PARTS & SERVICE	
NEWS

REF NO.
 AT01224

SUBJECT: REPAIR PROCEDURE OF TORQUE CONVERTER REGULATOR VALVE ON WA900-1

- **PURPOSE:** To introduce repair procedure of torque converter regulator valve on WA900-1 wheel loaders
- APPLICATION: WA900-1 Wheel Loaders, Serial Nos. 10001 thru 10703

4. Contents of the improvement.

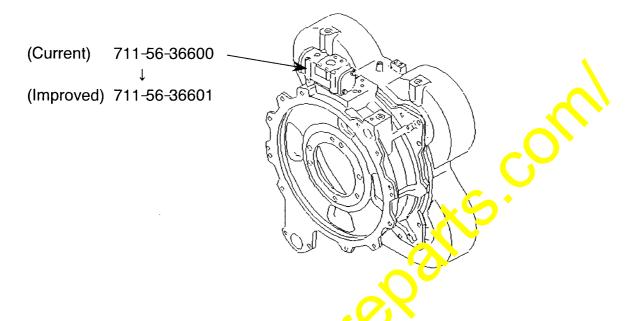
The performance of Regulator Valve has been improved.

The improved Regulator Valve makes the Torque Converter outlet pressure constant irrespective of oil temperature, and it prevents traction force from lowering, that is caused by the lower Torque Converter outlet pressure in higher oil temperature condition.

5. Identification method for the improved valve.

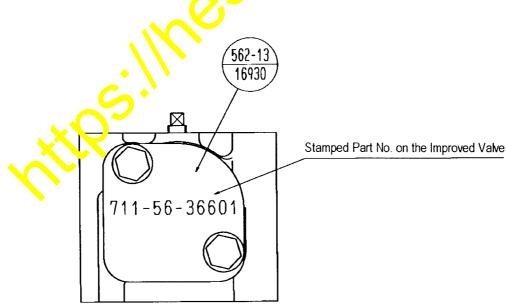
For the identification between the improved valve and the current valve, on the side plate (562-13-16930) of the improved valve, Part No. "711-56-36601" has been stamped.
